A. **MOOSE BED RIDGE:** The request is to create two lots from Parcel 4, MSB Waiver Resolution #98-83, recorded at Book 991 & Page 927, to be known as **MOOSE BED RIDGE**, containing 26.16 acres +/- . The property is located south of W. Pinnocle Lane, north of W. Glenn Highway, and west of W. Gamway Drive (Tax ID #20N09E30A007); within the NE ¼ Section 30, Township 20 North, Range 09 East, Seward Meridian, Alaska. In the Glacier View Community Council and in Assembly District #7. *(Petitioner/Owner: Hanson Land Solutions, Staff: Matthew Goddard, Case #2025-183)*

STAFF REVIEW AND RECOMMENDATIONS
PUBLIC HEARING
JANUARY 28, 2026

ABBREVIATED PLAT: MOOSE BED RIDGE

REVIEWED BY: MATTHEW GODDARD CASE #: 2025-183

RIGHT OF WAY MAP
ALASKA PROJECT
GLENN HIGHWAY M.P. 97 TO 100
PINOCHLE HILL
IM-0A1-5(7)

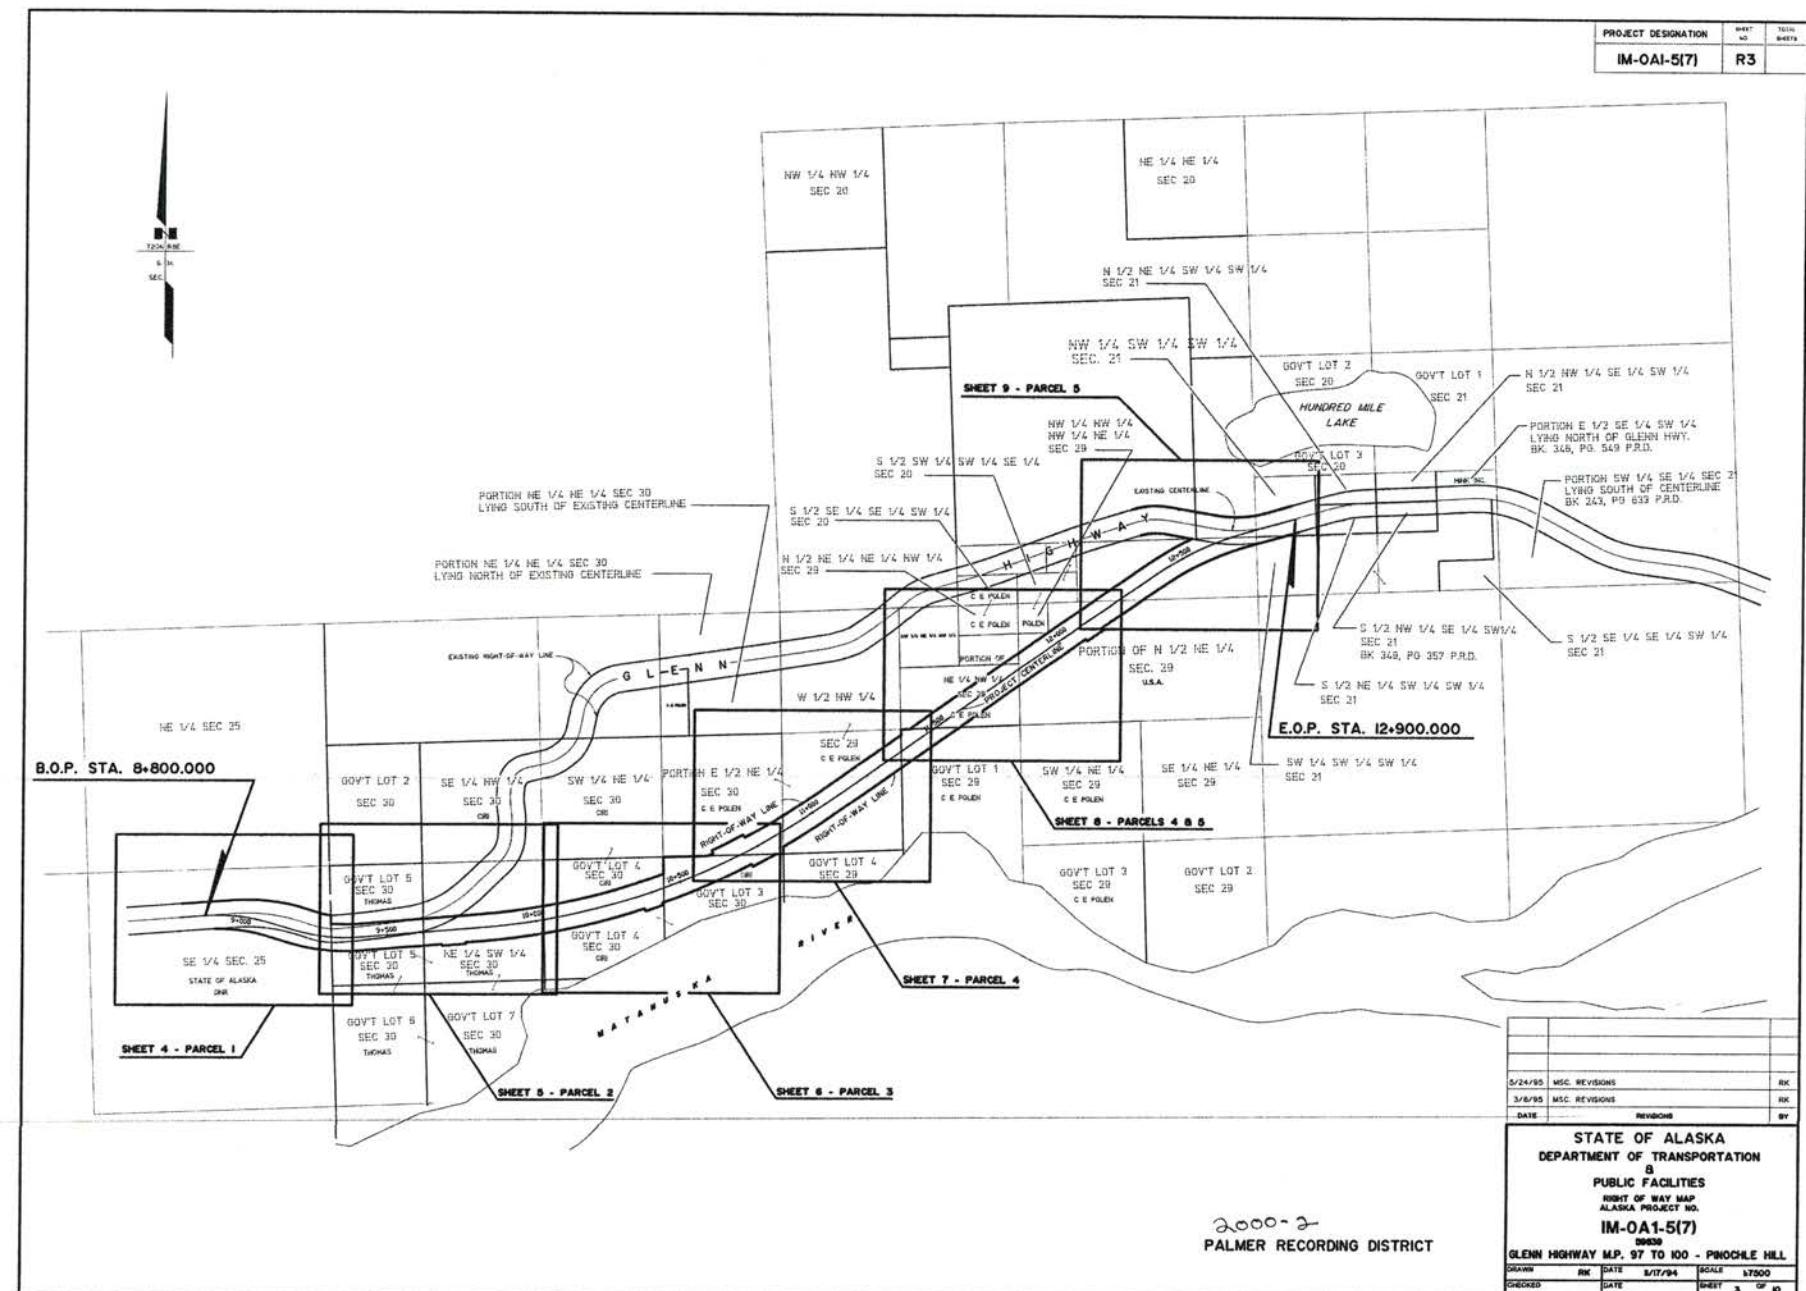
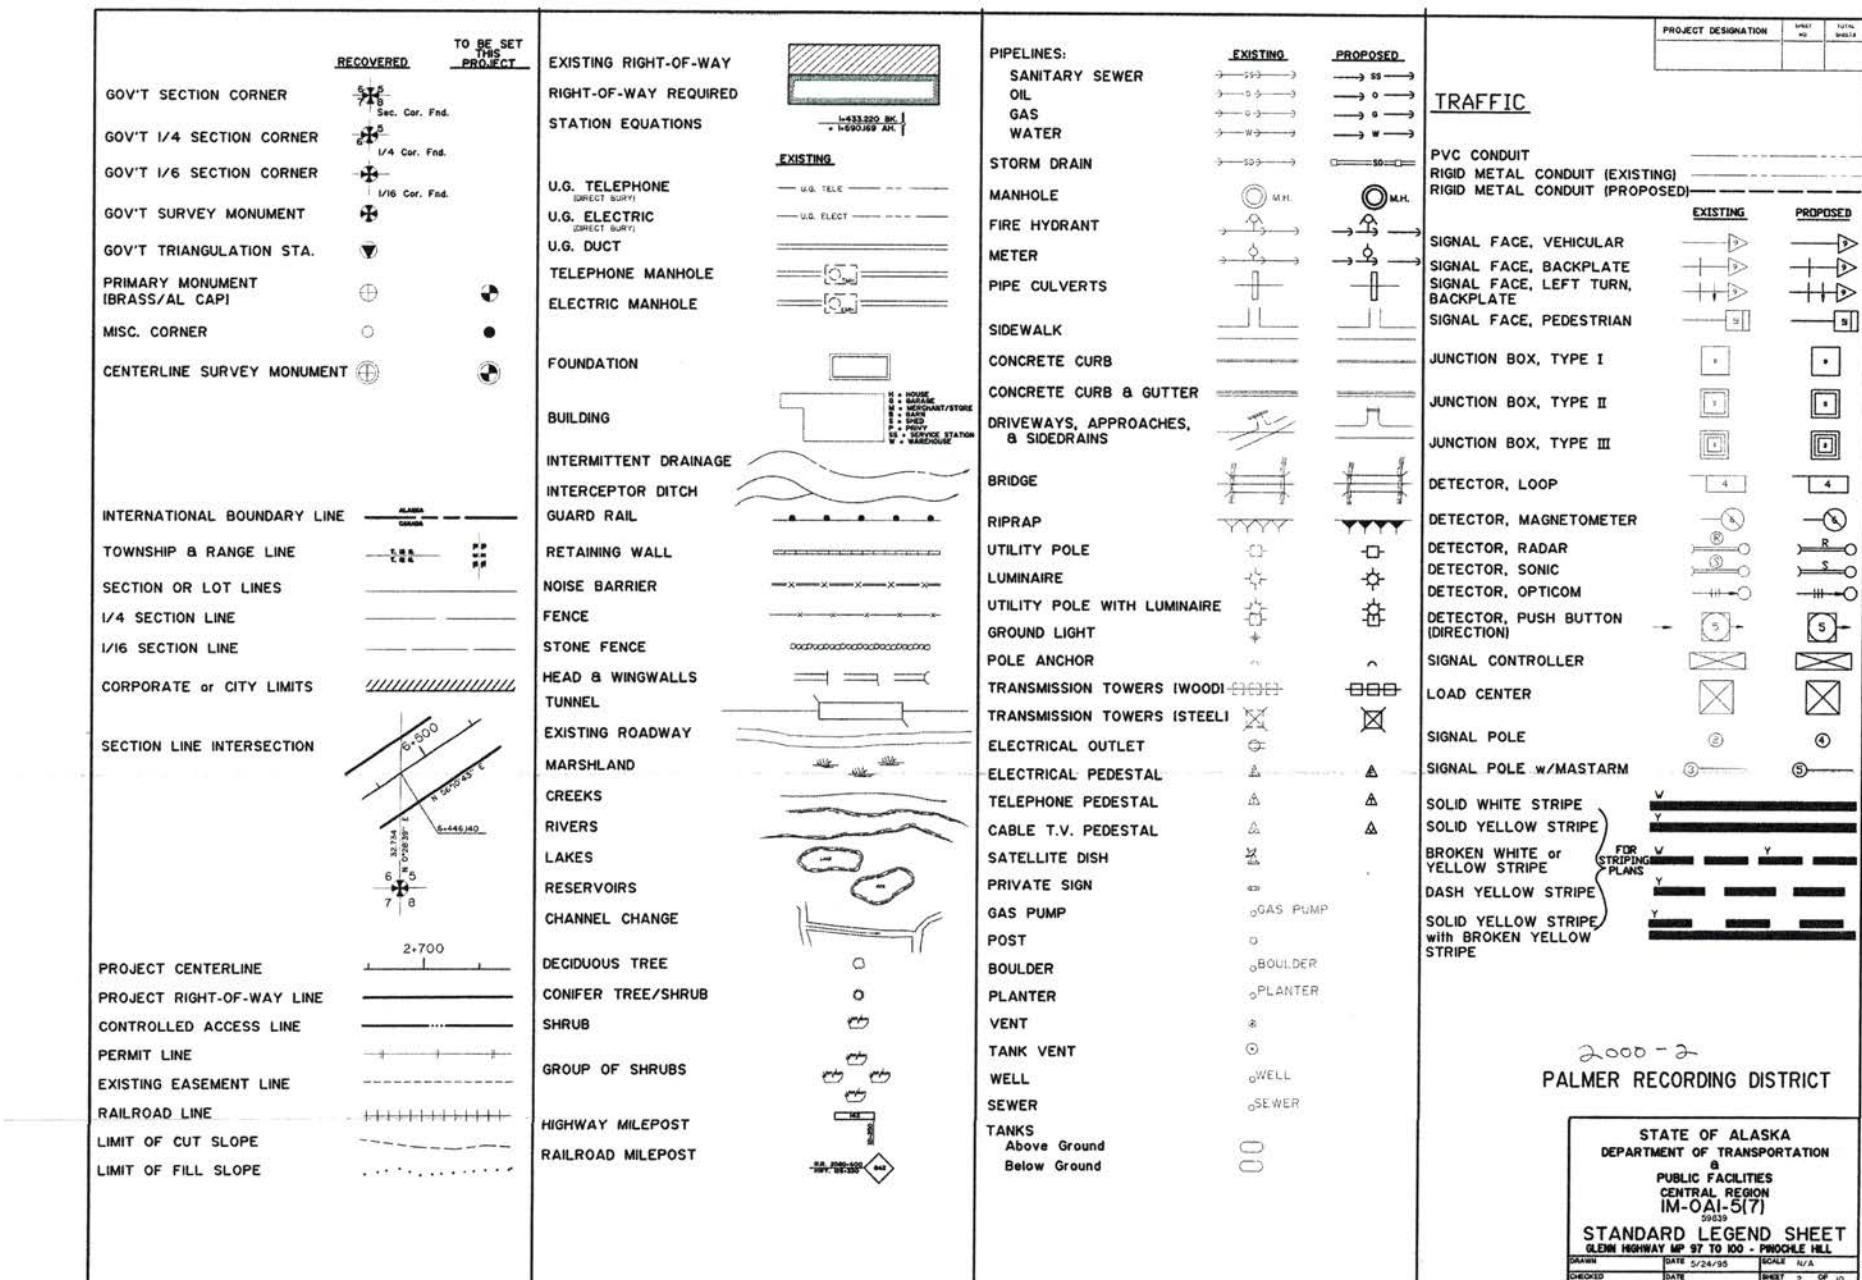
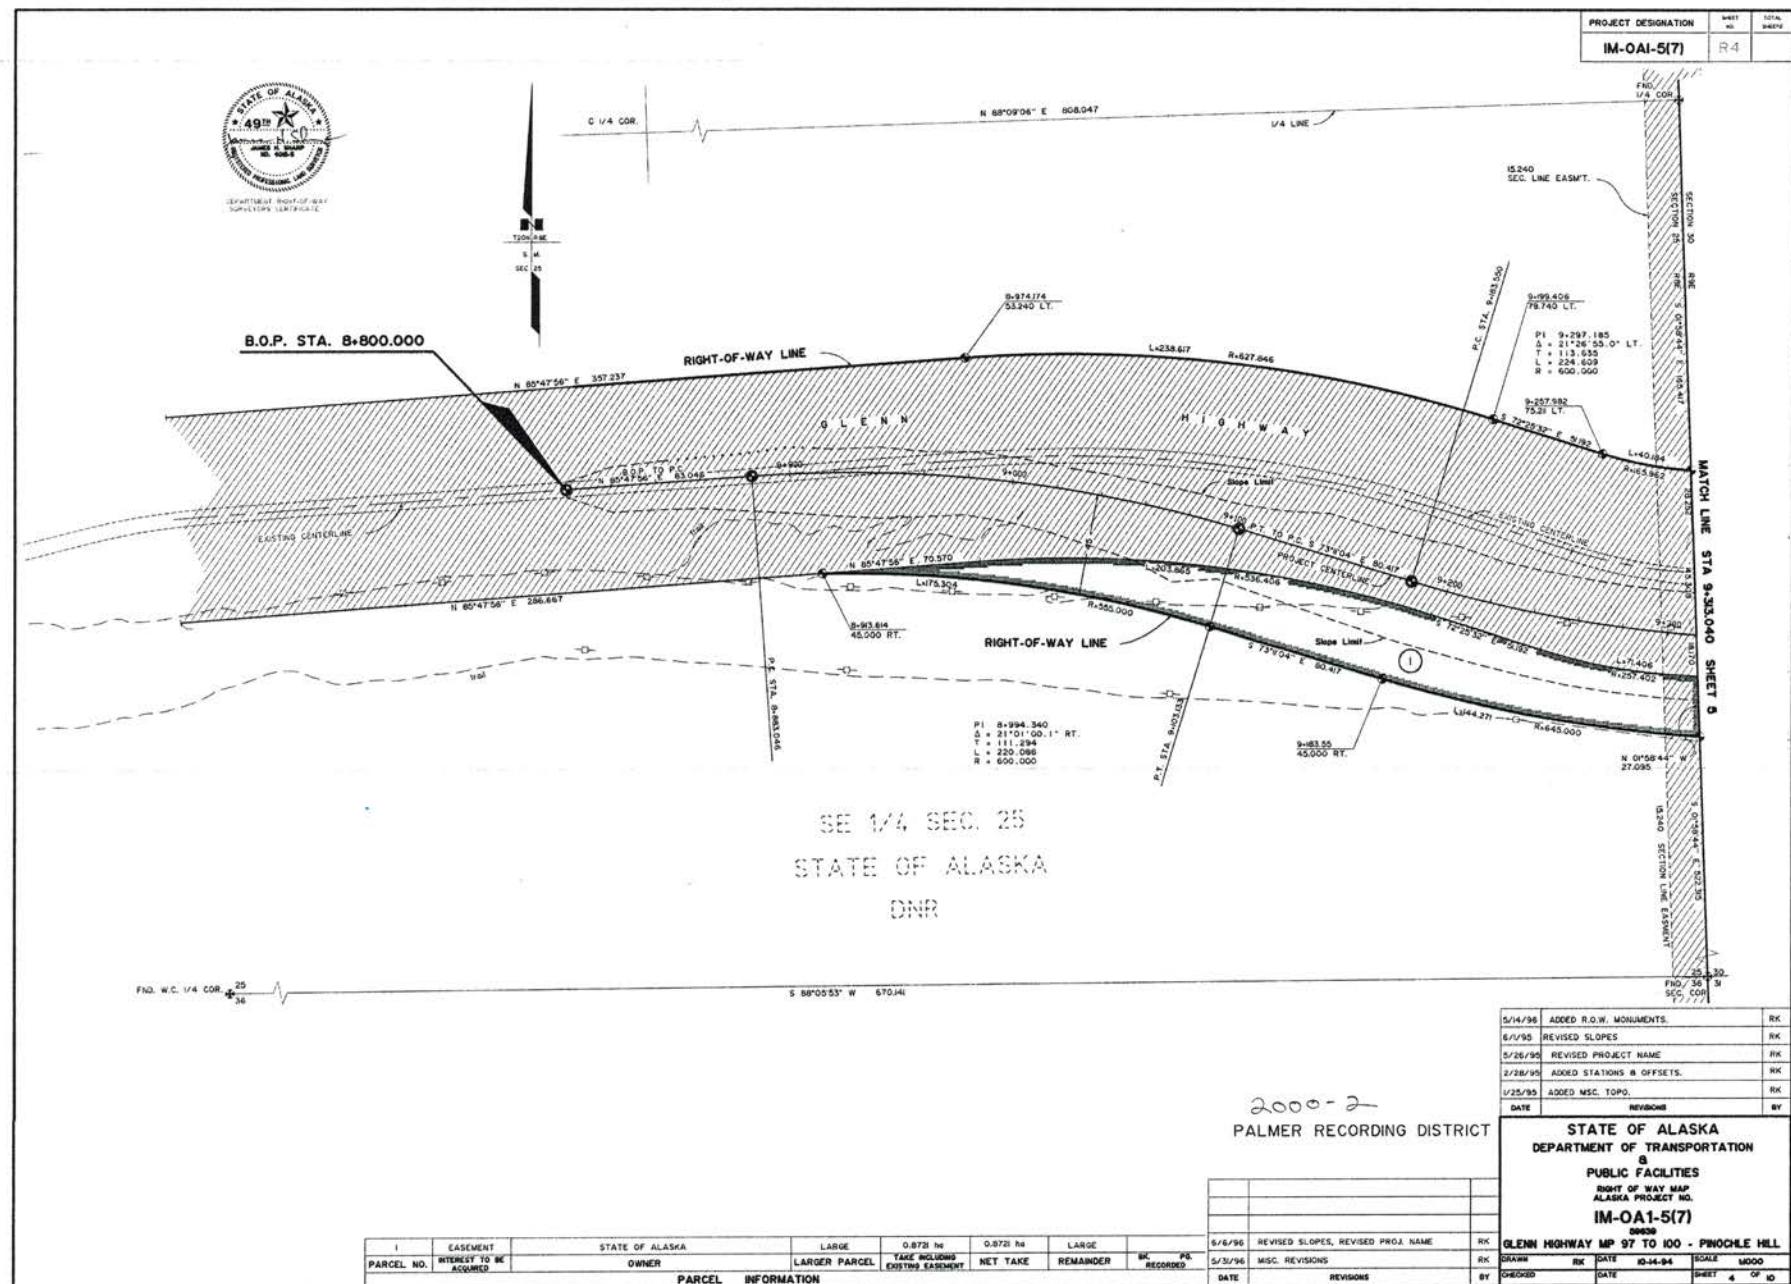
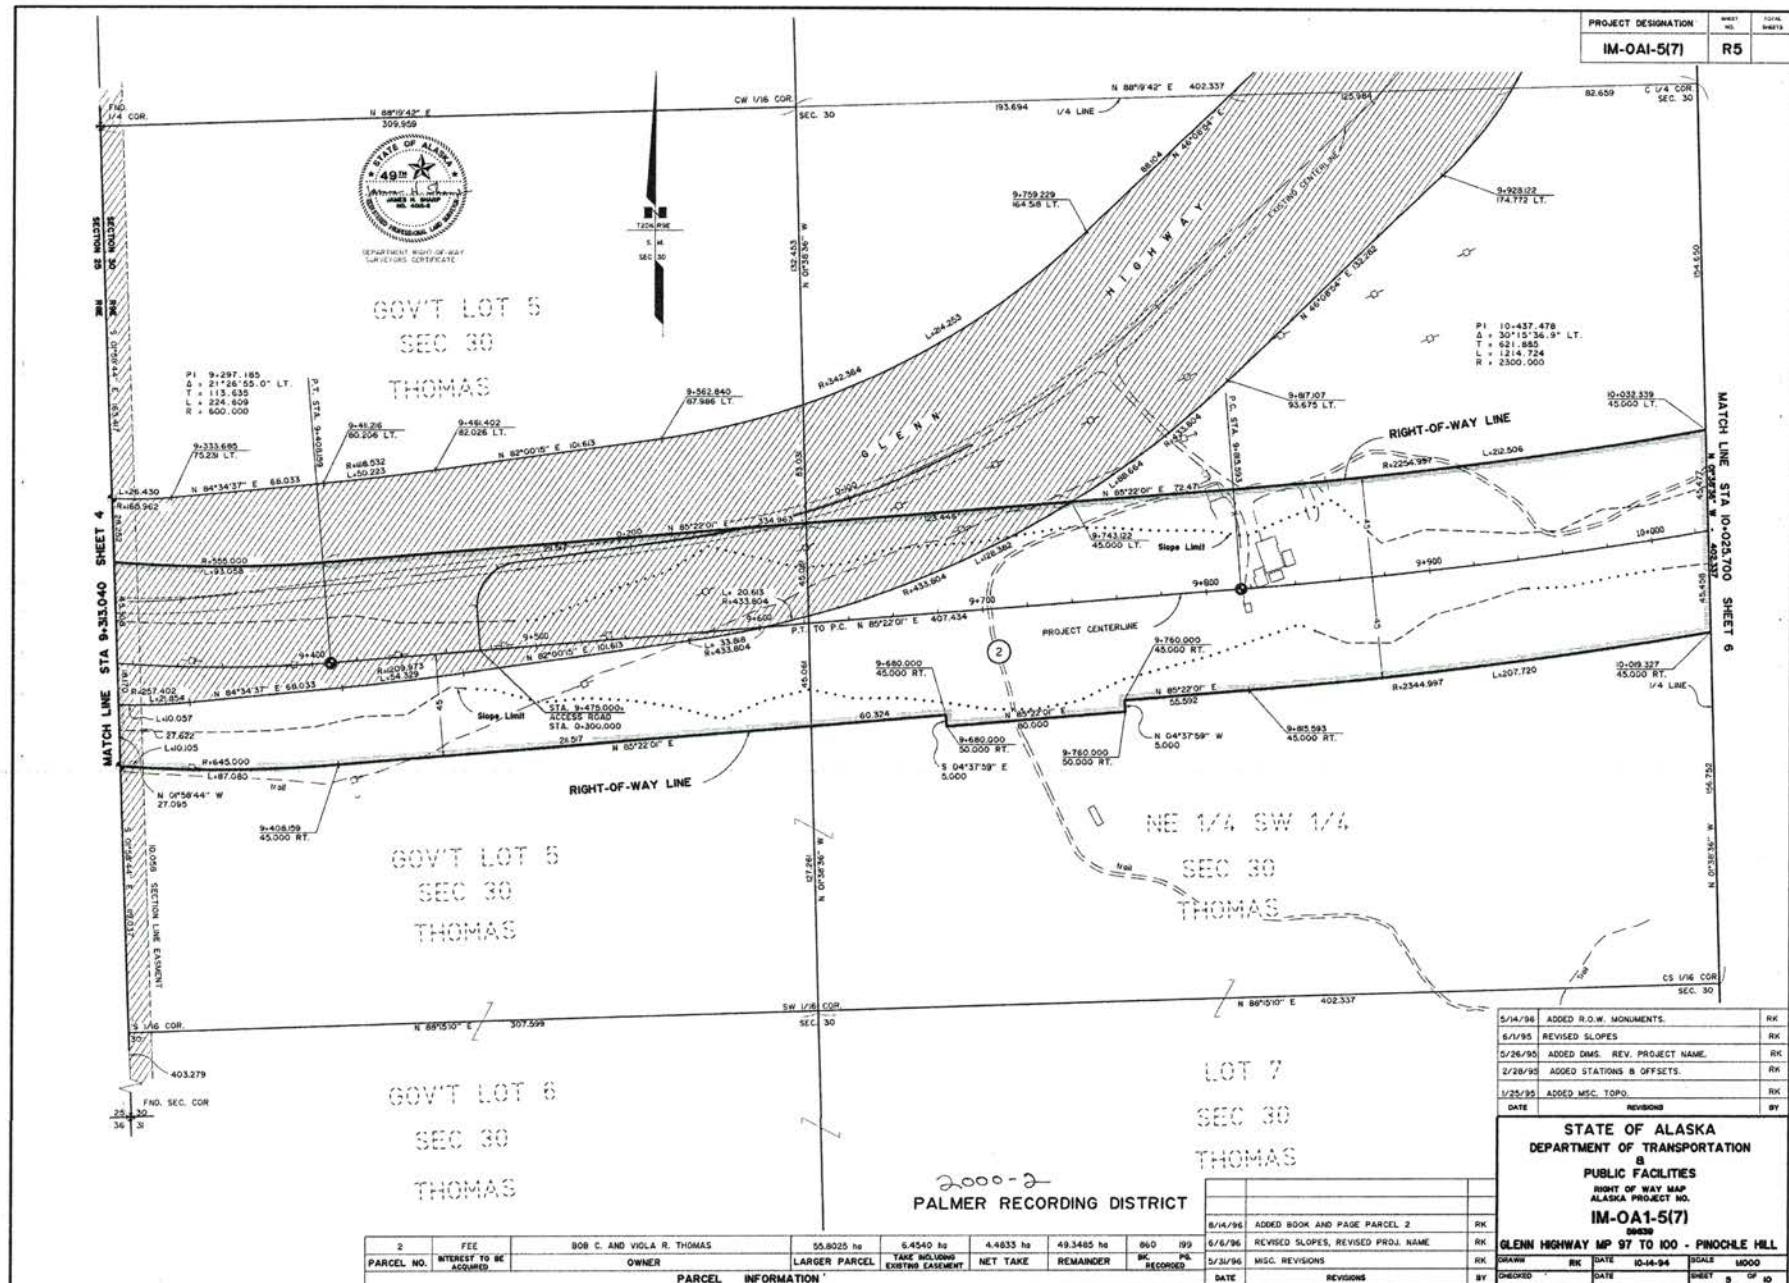
*This agenda plat does not match the ROW shown on 2000-2. Why is there a ~5' shift?
